January 14th, 2021

SUBJECT: TecJet 50+ and TecJet 52 (1st Gen) Product Support Statement

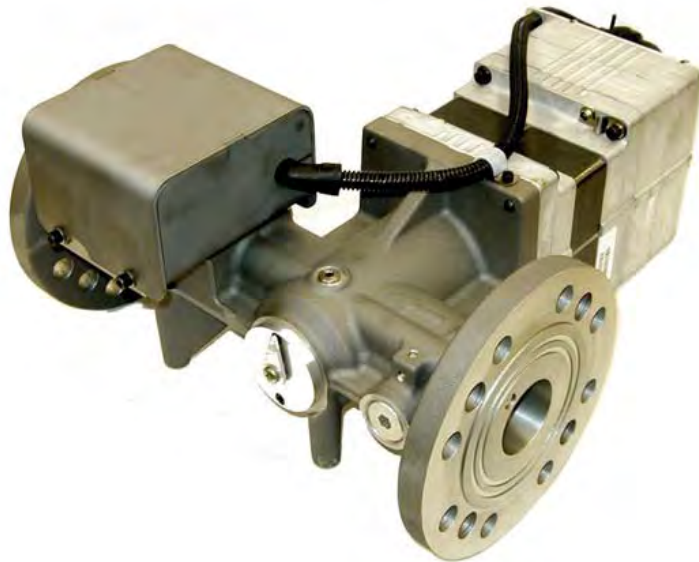
The key differences between the 1st and 2nd generation of TecJet 52 can be identified by:

- TecJet 50+ and TecJet 52 housings are made from a single casting.
- TecJet 52 (2nd Gen) is based on 35-pin F-Series ITB with mating flanges.

- Increased turndown ratio (from 65:1 to 110:1)
- Lower closed flow leak (20% closed flow area reduction)
- Improved environmental sealing
- More robust for special gases (improved bearing specification)
- Lower weight (31 lbs instead of 40 lbs)
 - Less vibration sensitive

Woodward discourages using TecJet 50+ and TecJet 52 (1st Gen) for any new applications or upgrades. We recommend the TecJet 37, TecJet 52 (2nd Gen), TecJet 85 and TecJet 110 for new design applications or product upgrades.
